Amendments to the Drawings:

“Annotated Sheets Showing Changes” and “Replacement Sheets” for Figs. 4, 7, 10, and 12 are enclosed herewith.

FIG. 10

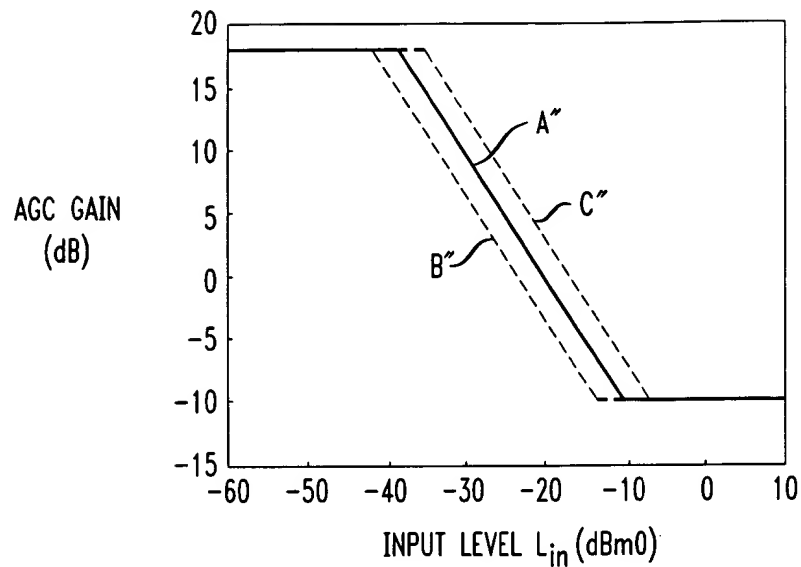
In Fig. 10, the lines labeled A, B, and C have been relabeled A", B", and C" to differentiate them from the lines labeled A, B, and C in Fig. 4. The dashed line A" has been redrawn as a solid line for consistency.

FIG. 7

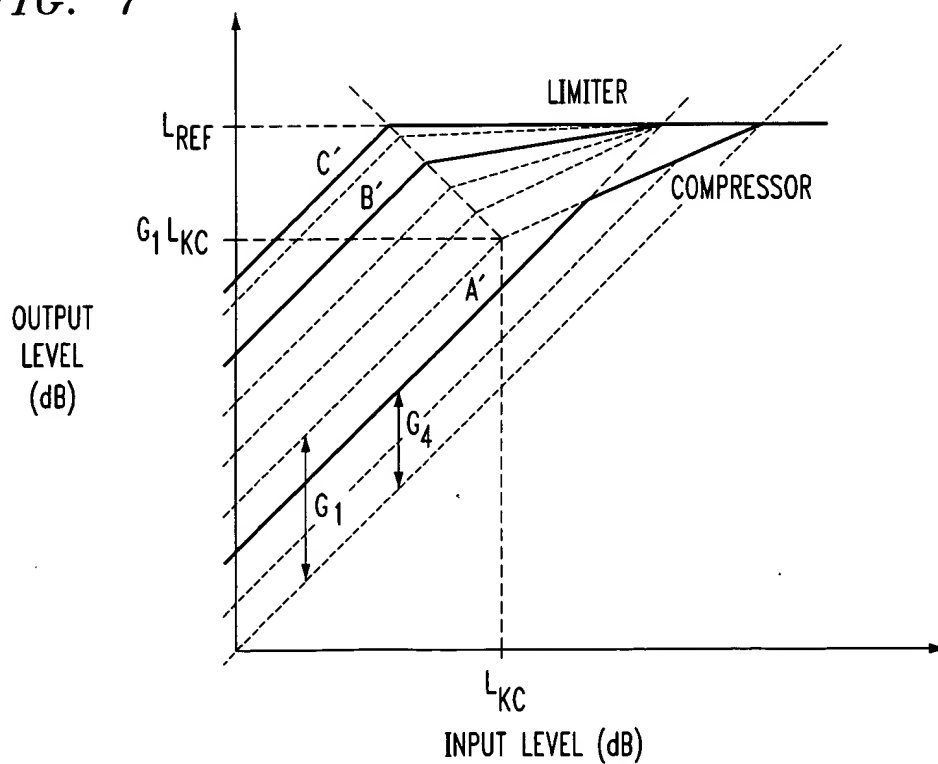
In Fig. 7, the lines labeled A, B, and C have been relabeled A', B', and C' to differentiate them from the lines labeled A, B, and C in Fig. 4.

FIG. 4

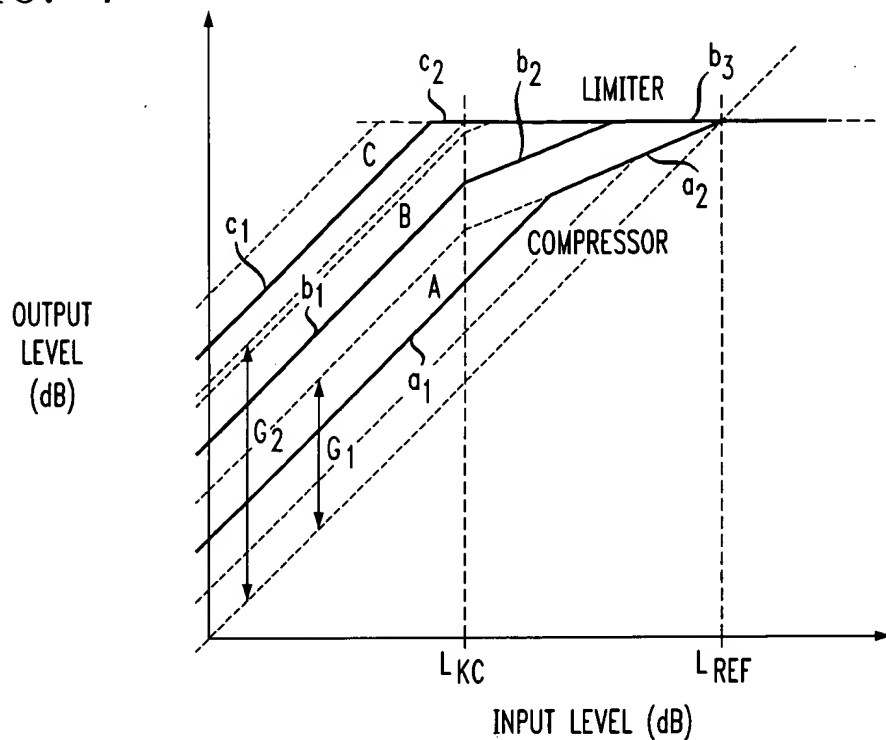
In Fig. 4, the composite line comprising sections  $a_1$  and  $a_2$  has been labeled by adding the letter A. The composite line comprising sections  $b_1$ ,  $b_2$ , and  $b_3$  has been labeled by adding the letter B. The composite line comprising sections  $c_1$  and  $c_2$  has been labeled by adding the letter C. These changes have been made consistent with the specification's references to lines A, B, and C in paragraph [0043].
